**AGENDA
TOWN OF CAMP VERDE
WORK SESSION
MAYOR AND COUNCIL
473 S. MAIN STREET, SUITE 106
THURSDAY, MAY 29, 2025 at 5:00 P.M.**

REQUESTING DEPARTMENT: Public Works / Engineering**STAFF RESOURCE:** Town Manager / Interim Community Development Director Miranda Fisher, Town Engineer Bruce Connolly, CIP Manager Martin Smith, and Utilities Director Jeff Low.**AGENDA TITLE:** Review and discussion of the Town of Camp Verde Engineering Design Standards Manual.**ATTACHED DOCUMENTS:**

**APPROVED BY TOWN OF CAMP VERDE COUNCIL FEBRUARY 16,
1994
REVISED MAY 21, 2025**

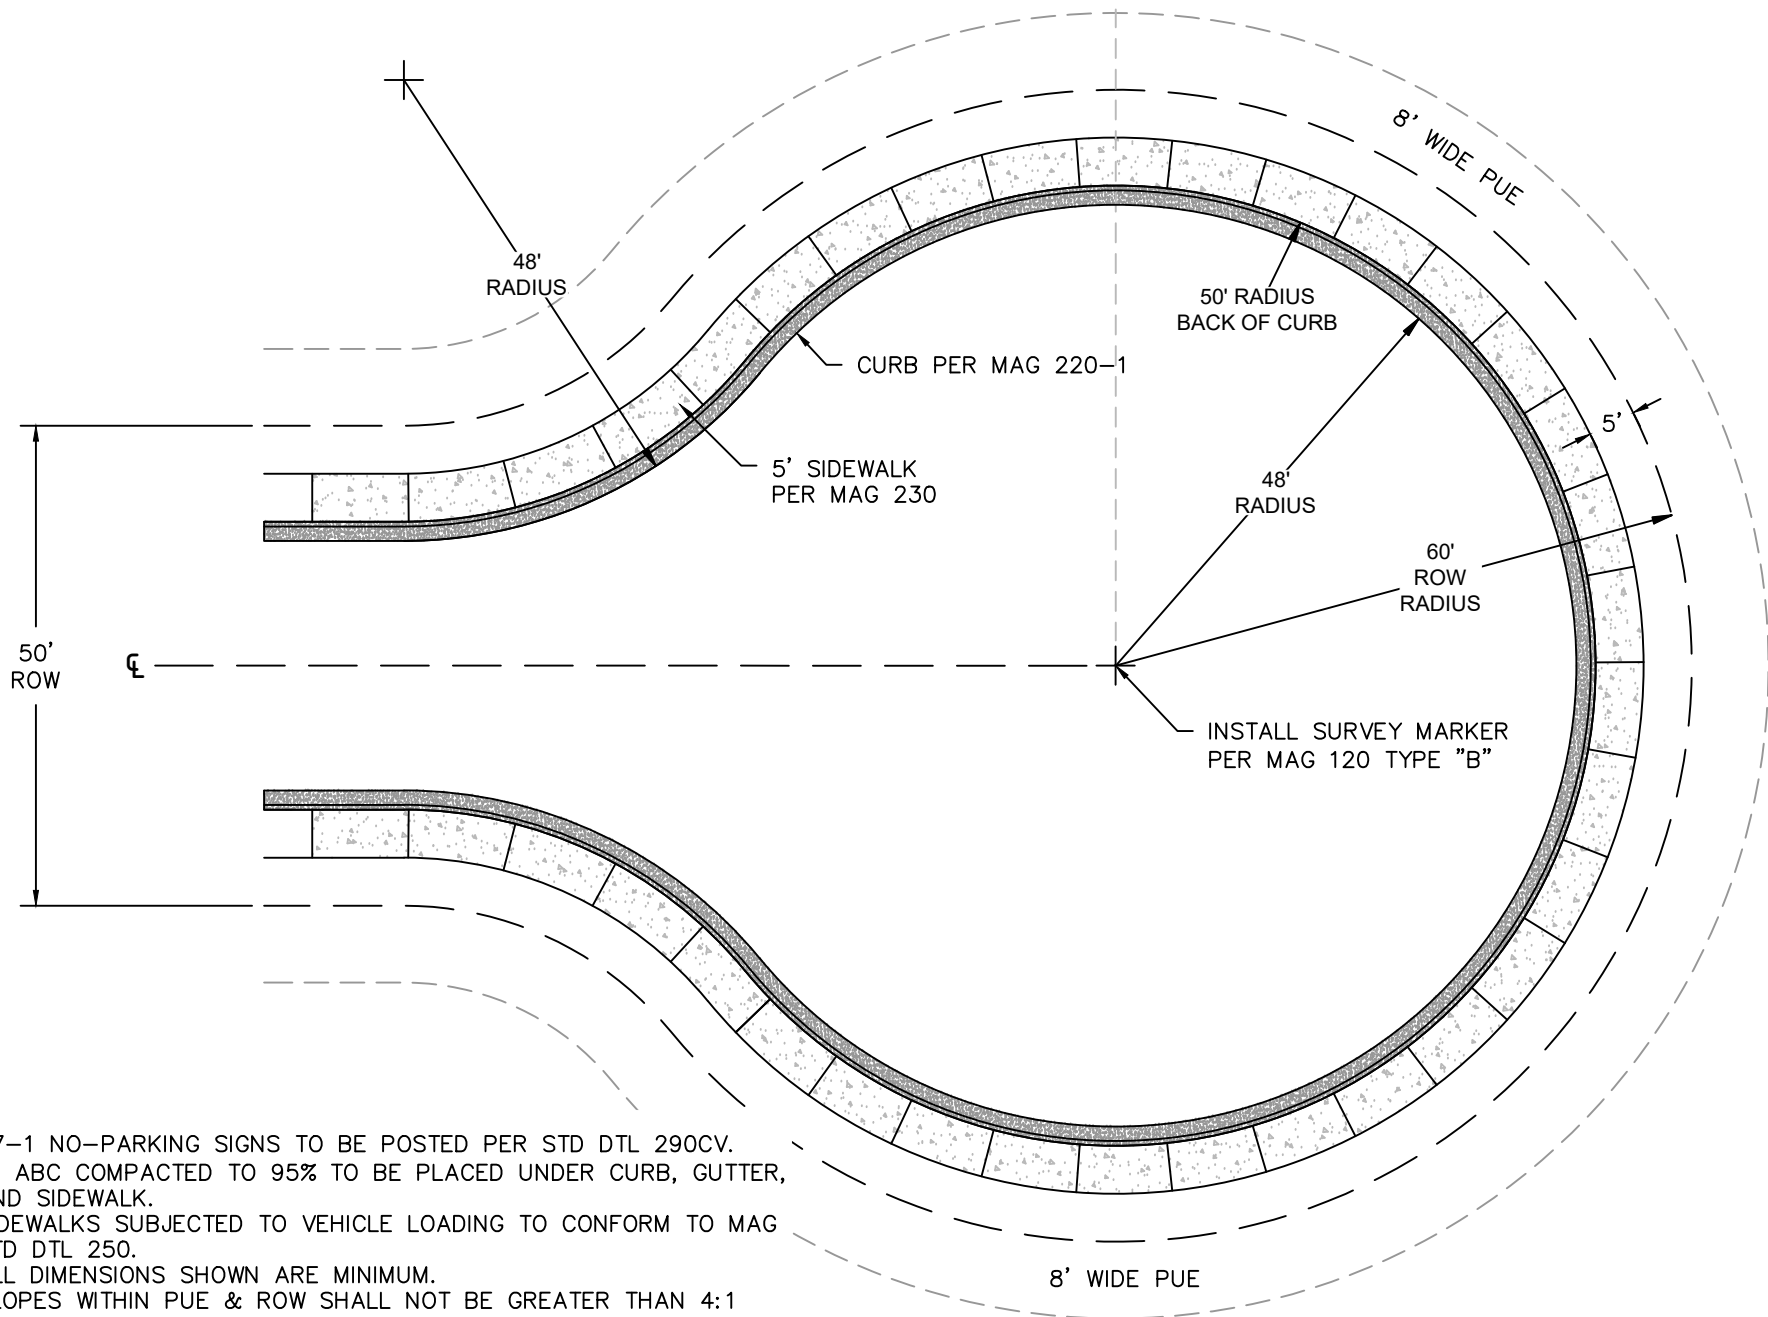
My third item of concern is Detail No. 288CV for the Rural Local Road. Note 1 reads that the road section is only to be used on subdivisions consisting of 10 single family units or less. I feel this could be better governed by size of lot rather than number of homes. My suggestion is it should be worded in a manner that Detail No. 288CV usage will be “considered” for subdivisions consisting of single family units with lots of ½ acre or larger. There should also be some verbiage stating that the roads are not to be designed to direct or manage drainage. This would fully alleviate the need for curb and gutter.

Detail 288CV

Detail 420CV-1 –

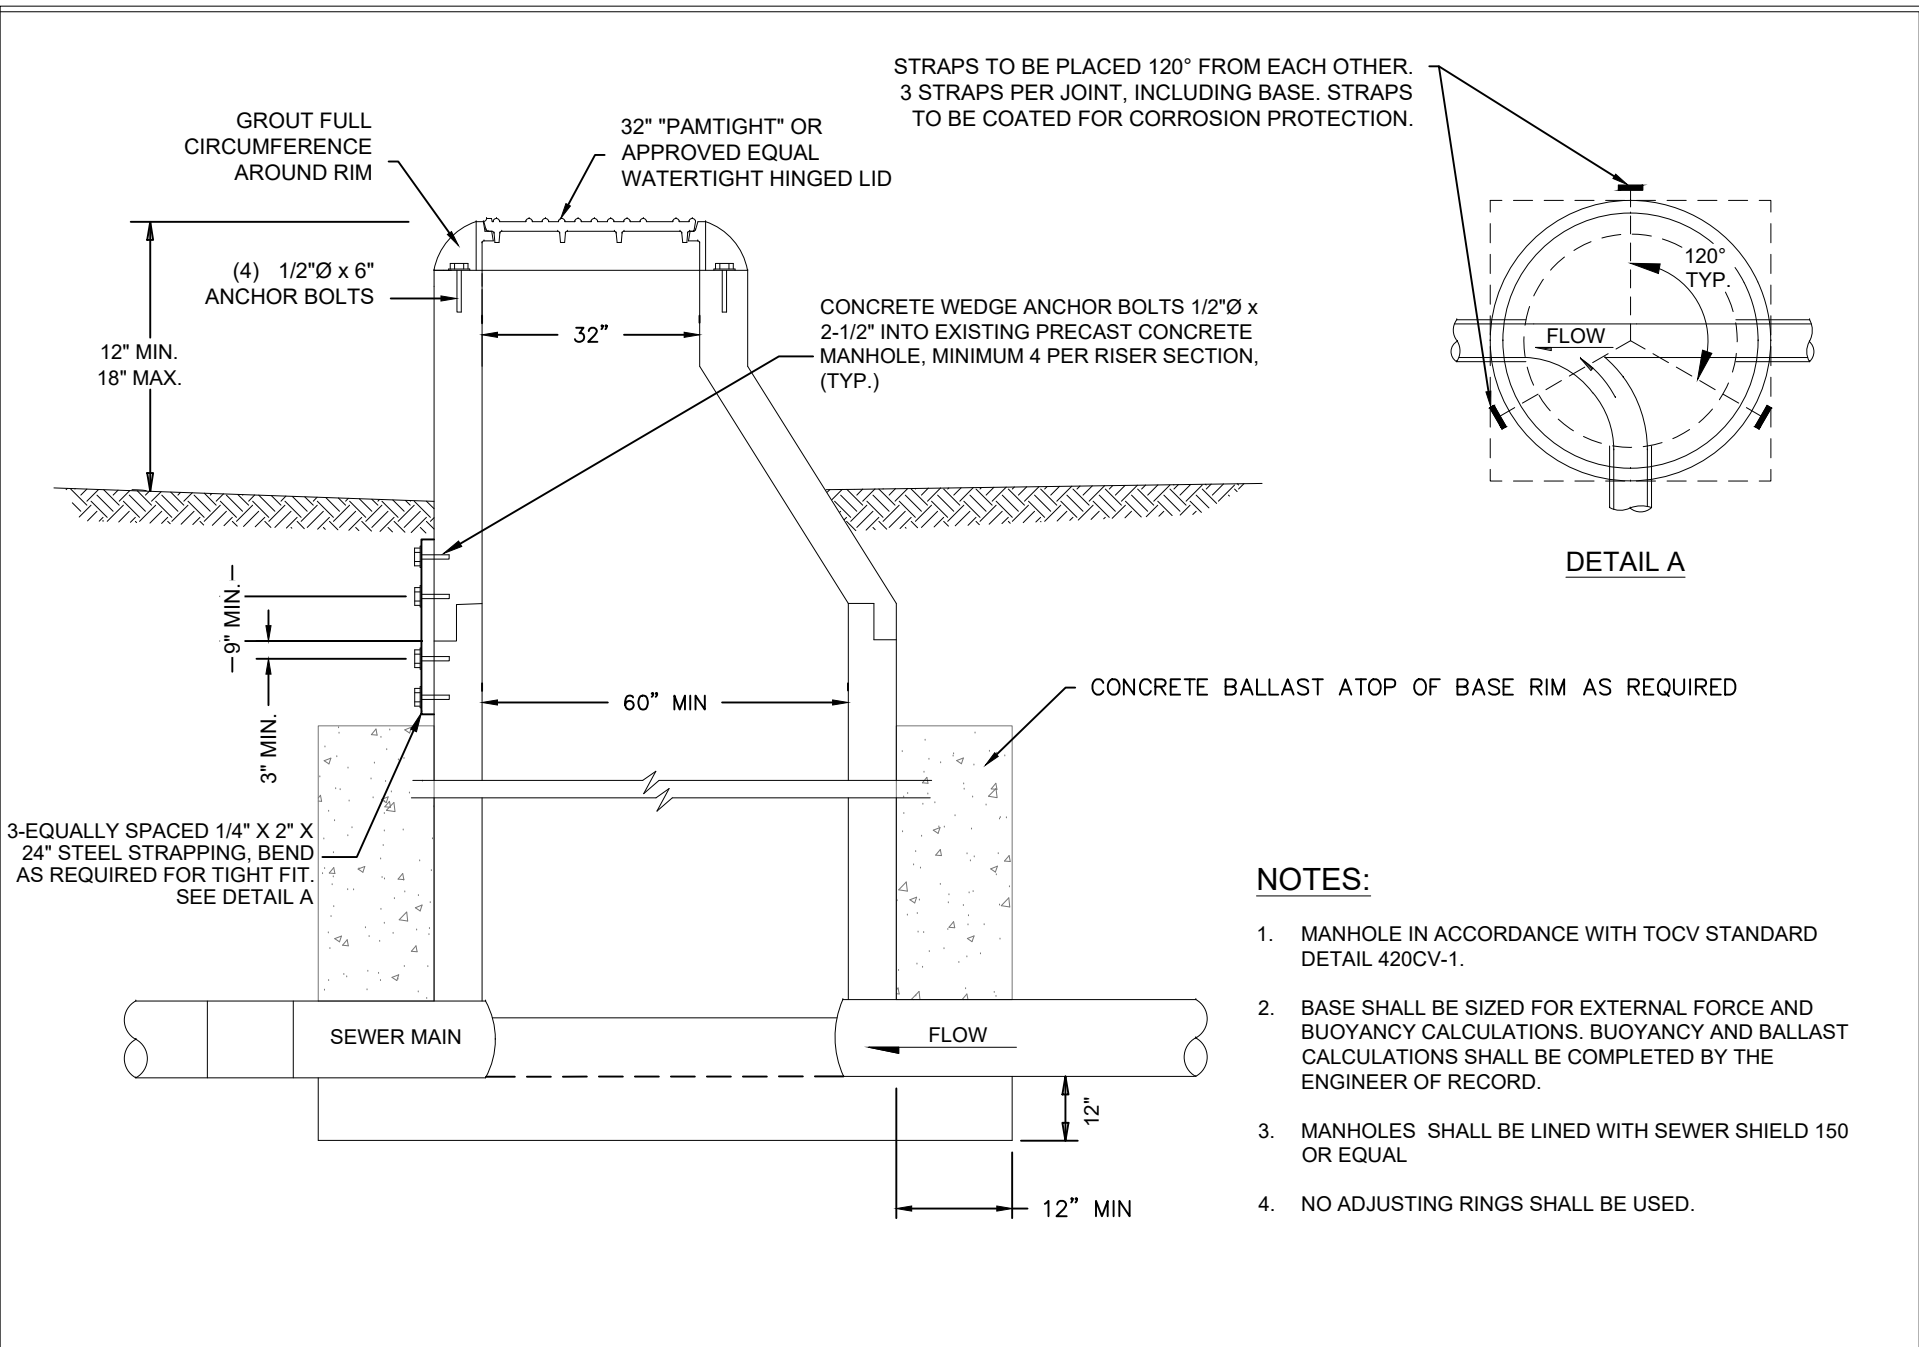
- Utilities require the protective coating (sewer shield 150 or equivalent) to be applied to protect the manhole from the corrosive gasses of the sewer. If the contractor doesn't coat the manholes, then the Town will need to, which is an added expense on an already strained budget. Hydrogen sulfide (H₂S) gases regularly degrade concrete over time. The Quad City Standards (Prescott, Prescott Valley, Chino Valley, and Dewey-Humboldt) all have sewer manhole coating requirements. This is typical for most municipalities.

- Polymer Concrete is required by Utility Department when deep or within main roads to protect the Town from having major construction from a failed manhole. When it comes to tax dollars, one could argue the cost of tearing out a failed manhole 50 years in the future warrants the higher standards. Polymer manholes have a lift expectancy of over 100 years versus 50 years and the polymer material will not degrade with H₂S gases. Armorock Manholes include a 50 year warranty. This polymer manhole requirement is only for manholes located in busy intersections and for manholes with significant depths, 15 feet or great. This requirement is to save Town taxpayers from any significant maintenance requirements associated with these manholes.
